Service Info

Remedy for noises

from accessory drive area in Ford Transit

Part no.: 535 0223 10

Image 1: Changing a rigid belt pulley to an over-running alternator pulley

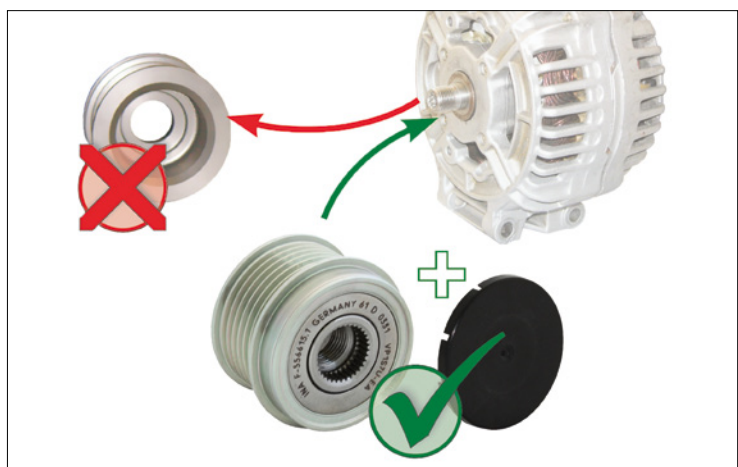
Image 2: When installing the over-running alternator pulley on a Bosch alternator, the enclosed spacer with a thickness of 1.4 mm must be used!

Due to the strong, dynamic movements of the V-ribbed belt, loud noises may be produced in vehicles with a rigid alternator belt pulley.

As a technical solution, Schaeffler Automotive Aftermarket offers an over-running alternator pulley for these vehicles. This reduces the dynamic loads in the accessory drive, thus preventing noise.

Schaeffler Automotive Aftermarket recommends that the vehicles affected be retrofitted with an over-running alternator pulley 535 0223 10.
